DONCASTER BEVERLY DANBURY RECONSTRUCTION

ASSESSMENT DISTRICT - 2024

CITY PROJECT NO. 14079
CONTRACT NO. 8709

REVISION #1- 8/15/2024
REVISED THE FOLLOWING:
EC4, EC6, G11, G13-G15, PD2-PD6, P2-P6, U4-U5, W1, X4-X5, X7, X9, X12

BEVERLY ROAD PLAN & PROFILE
DONCASTER BEVERLY DANBURY RECONSTRUCTION
M:\DESIGN\Projects\14079\CAD\Streets\14079EN-PrP.dwg

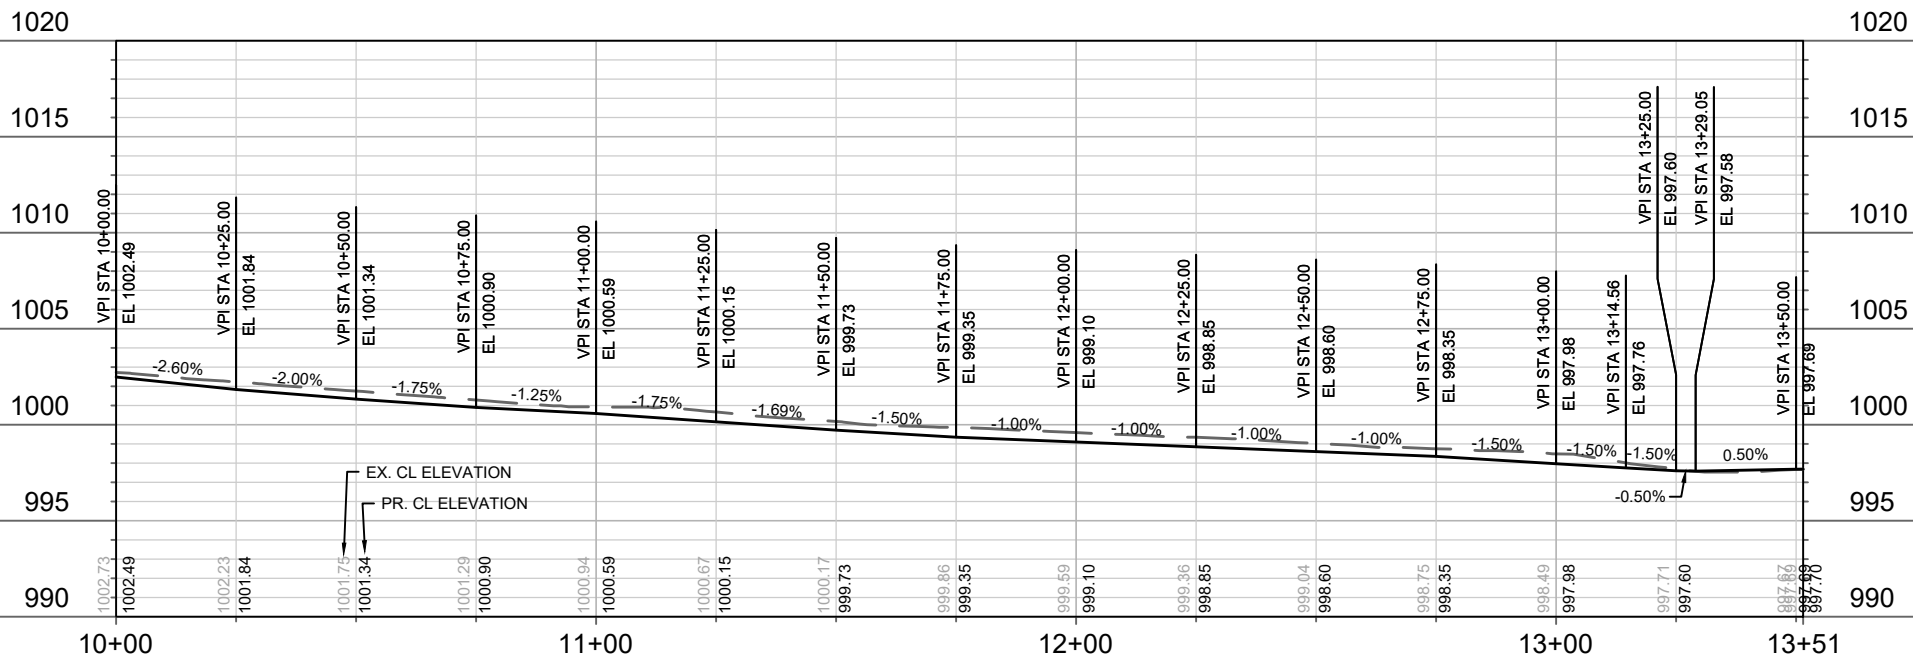
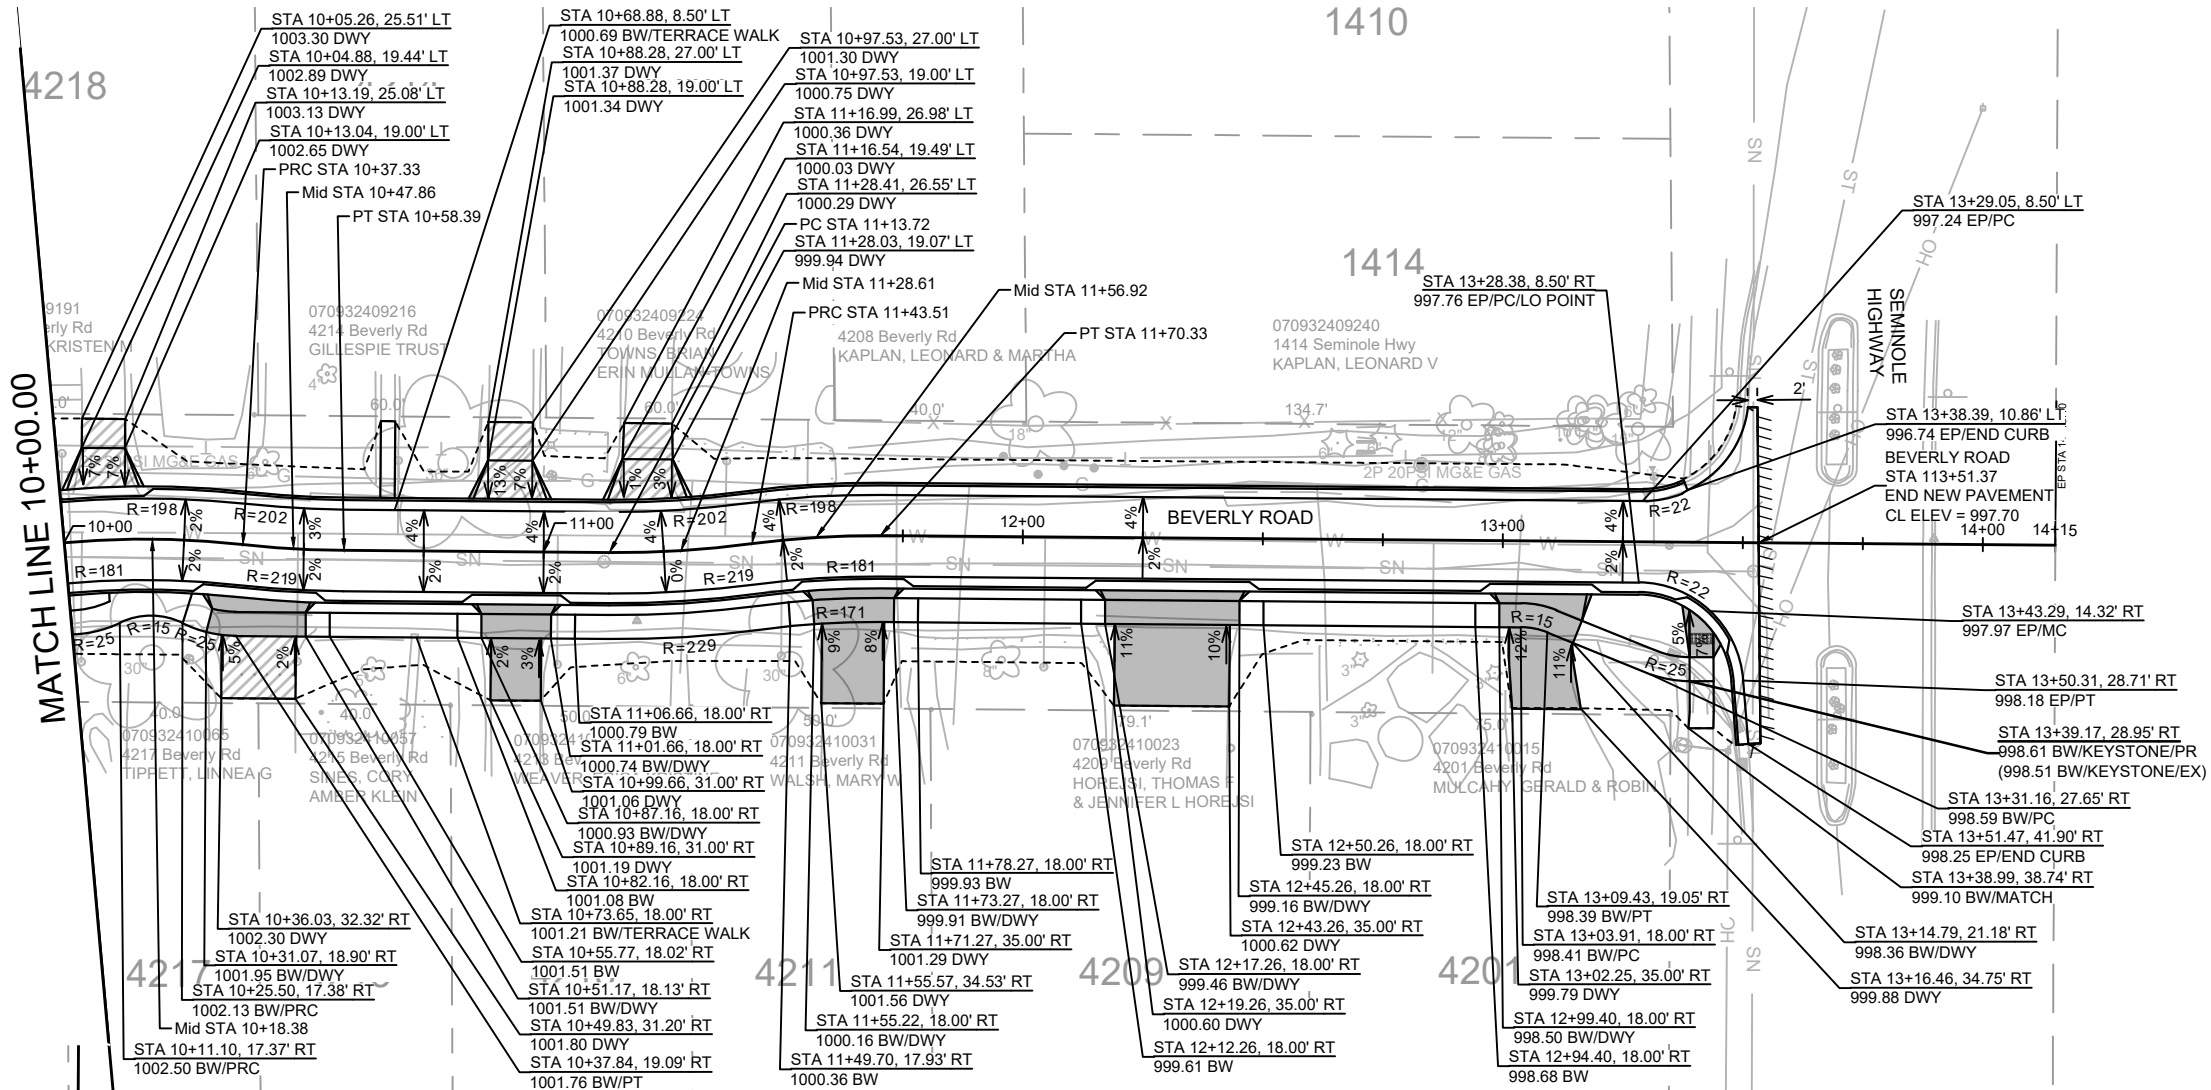
REVISION 1:
UPDATED DRIVEWAYS
TO MATCH LATERAL
GEOMETRY

DONCASTER DRIVE PLAN & PROFILE
DONCASTER BEVERLY DANBURY RECONSTRUCTION
M:\DESIGN\Projects\14079\CAD\Streets\14079EN-PrP.dwg

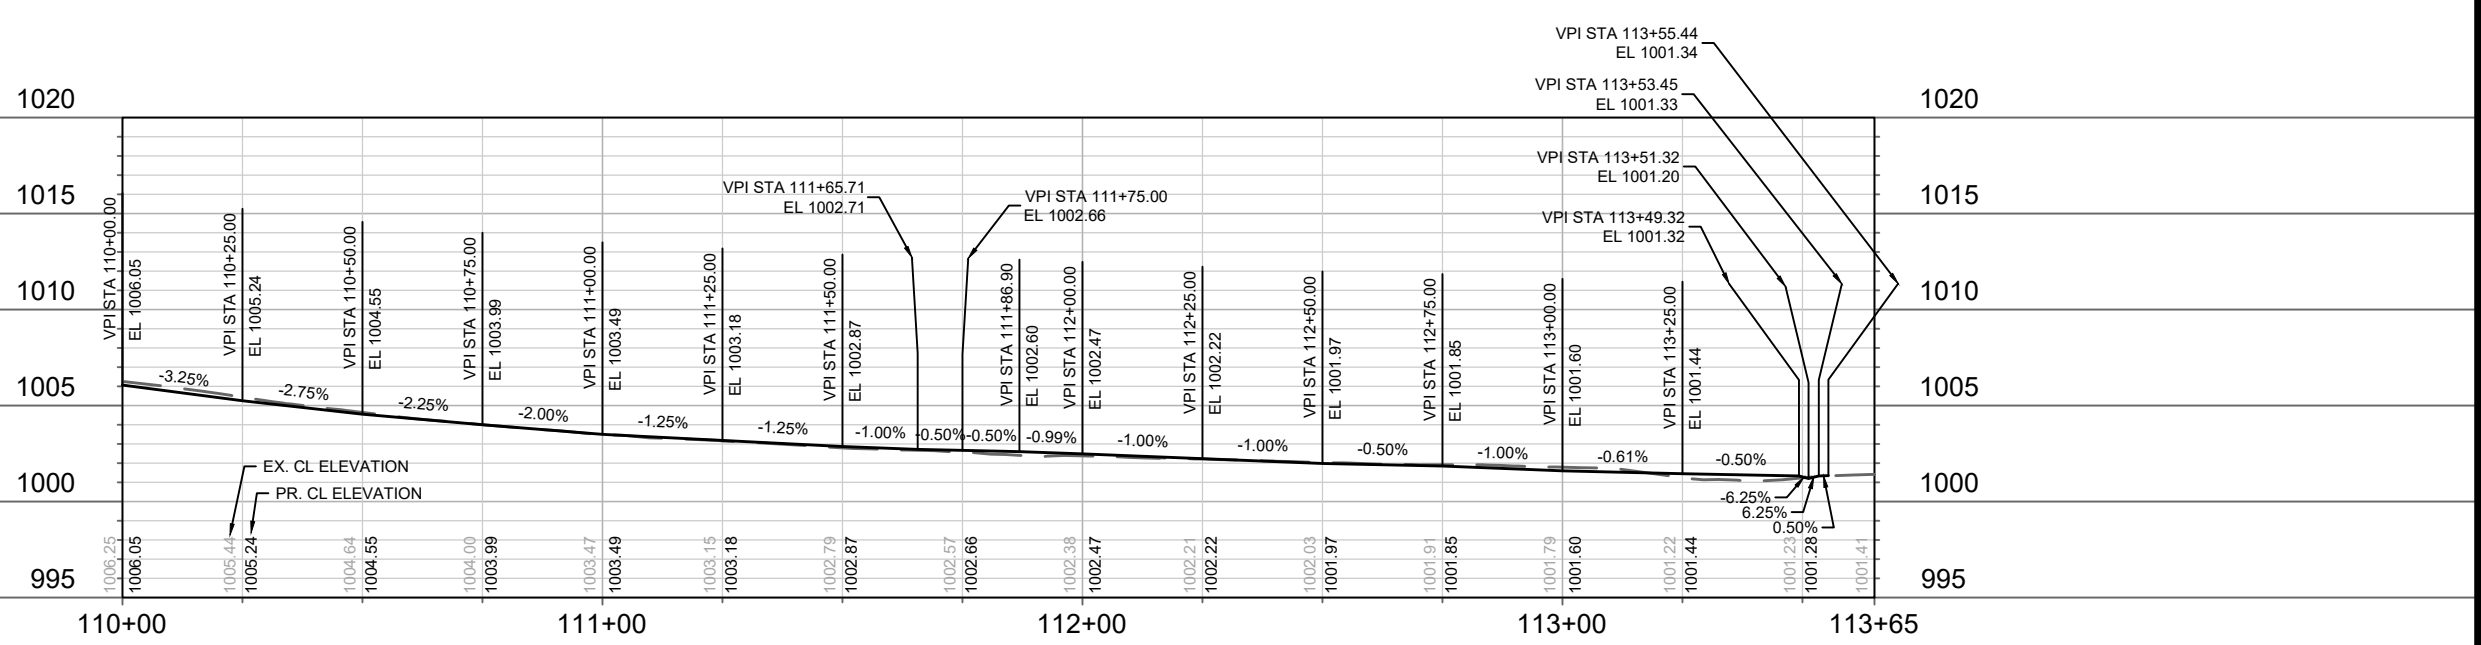
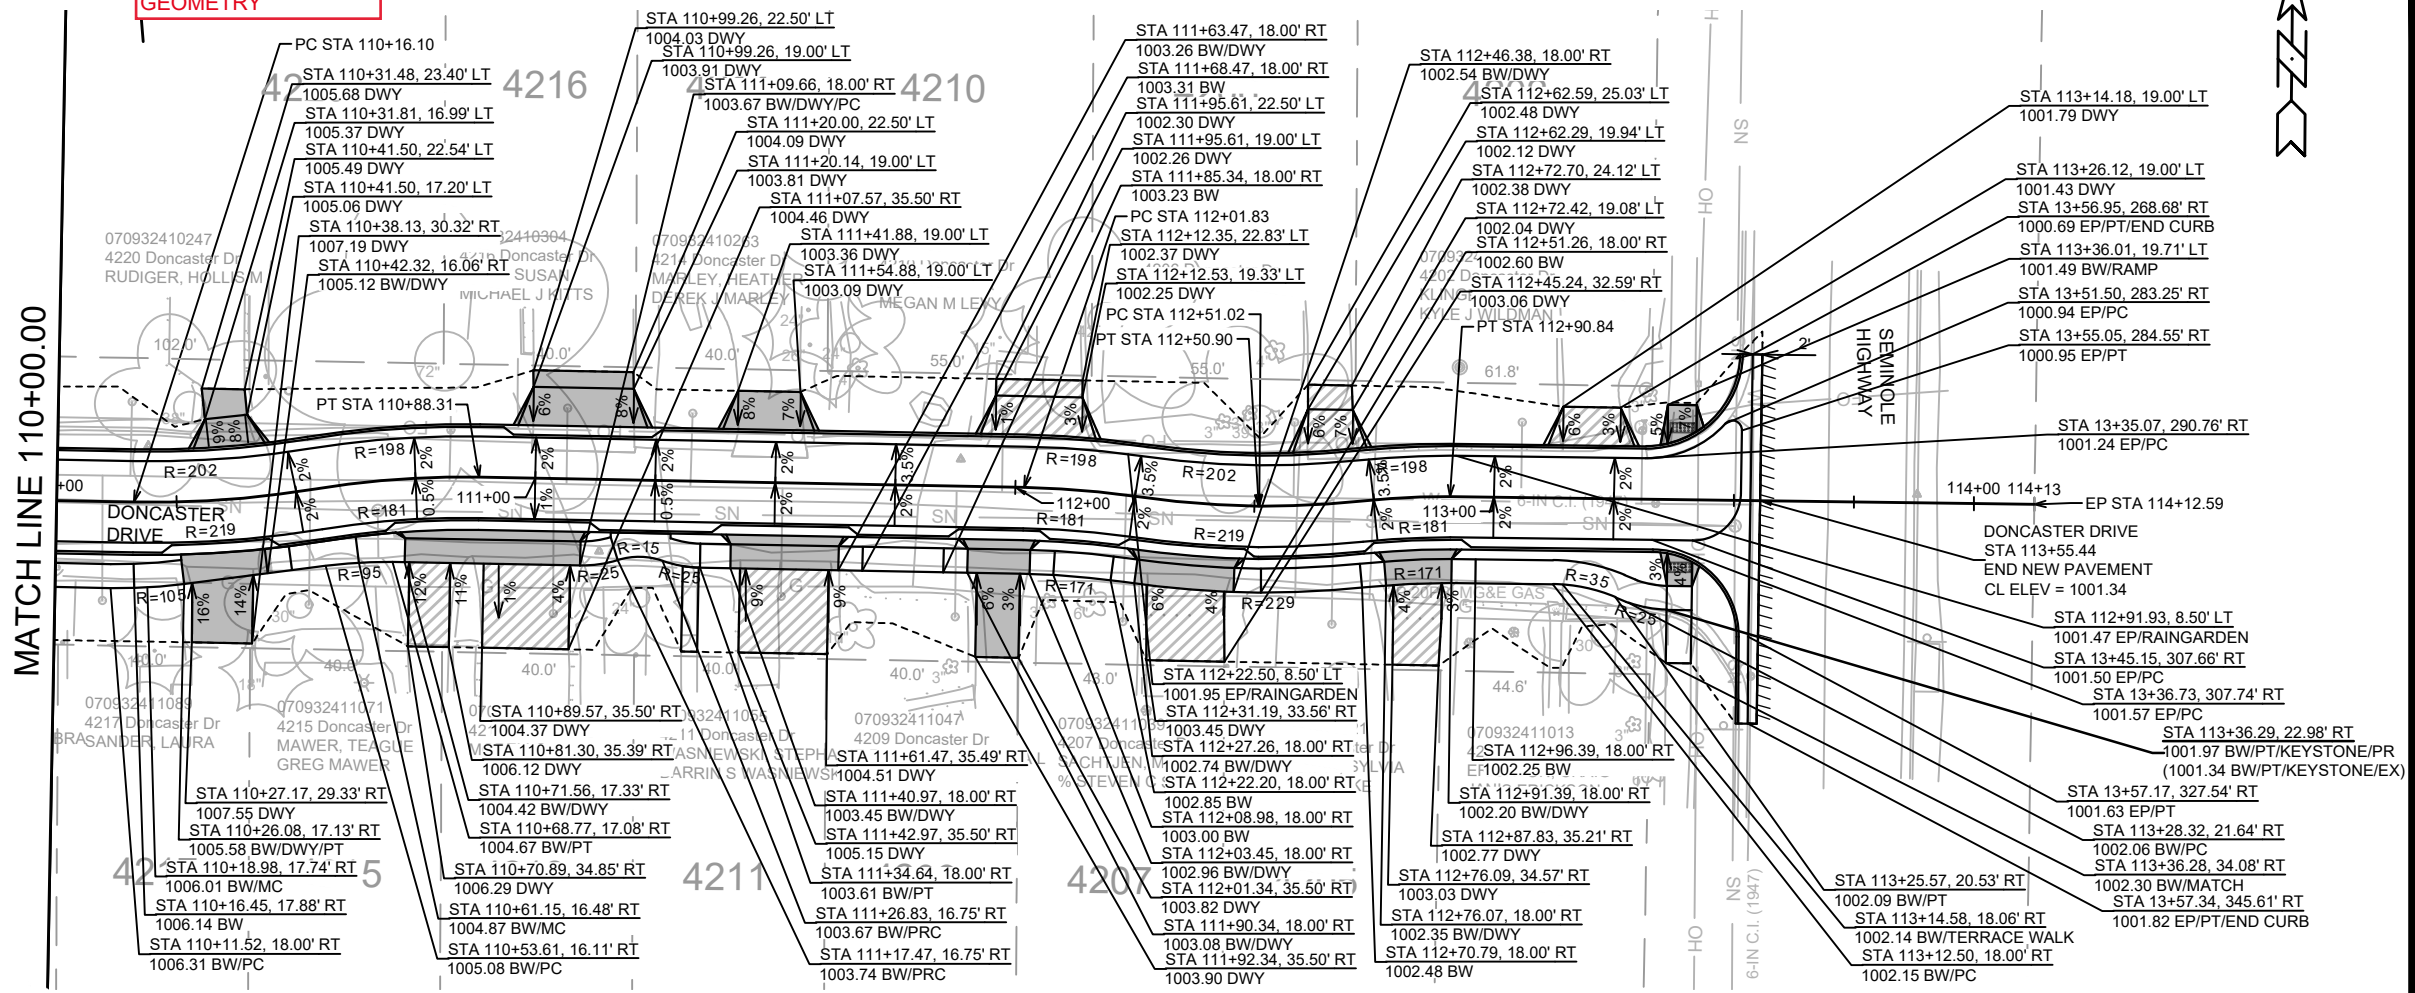
**REVISION 1:
UPDATED DRIVEWAYS
TO MATCH LATERAL
GEOMETRY**

MARK	AD#1	REVISION	Date: 5/17/2024 8:10 AM	Scale: 1" = 40'
DATE	5/17/24	EKG	BY	U-2

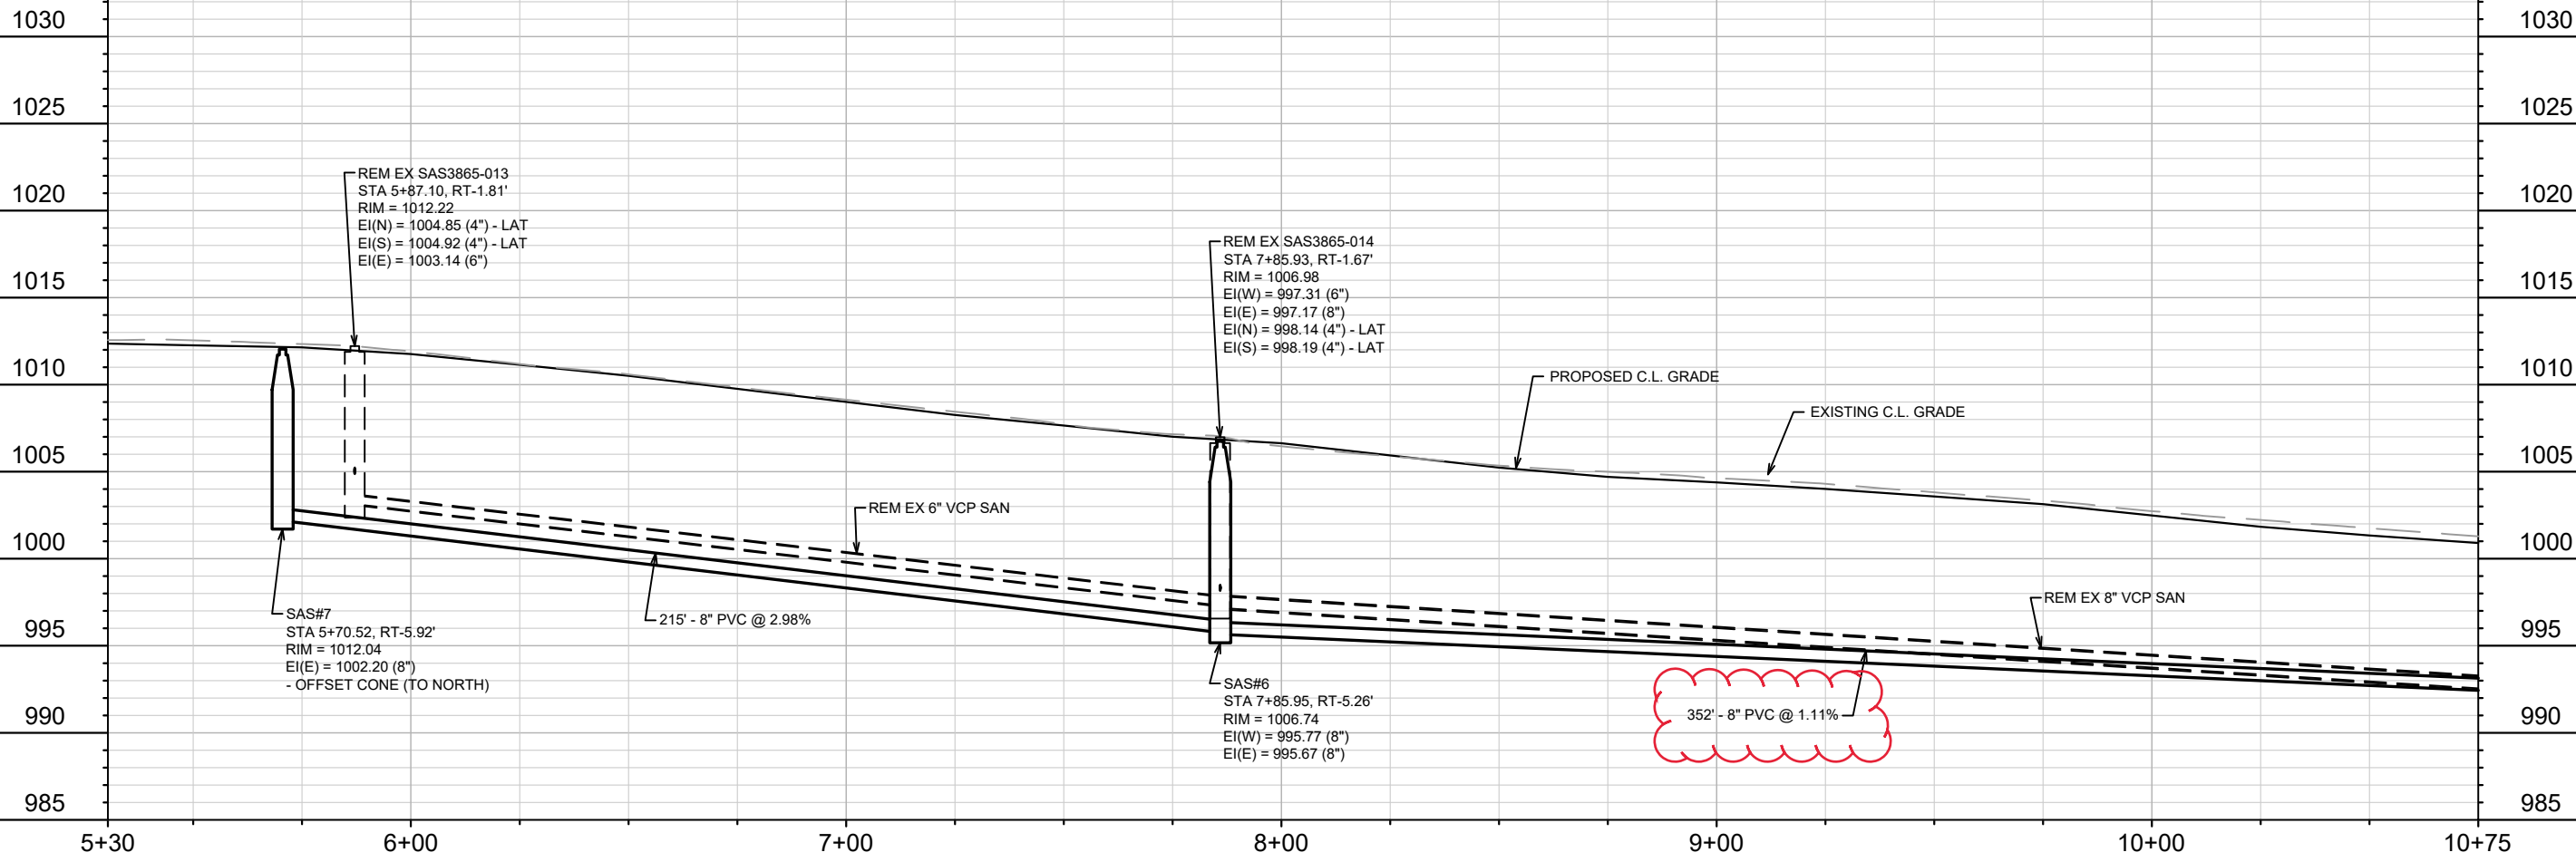
ADDENDUM NOTE:
 ADDED RETAINING WALL AT 4233
 BEVERLY RD. UPDATED LENGTH OF
 PIPE FROM SAS#5 TO SAS#6.
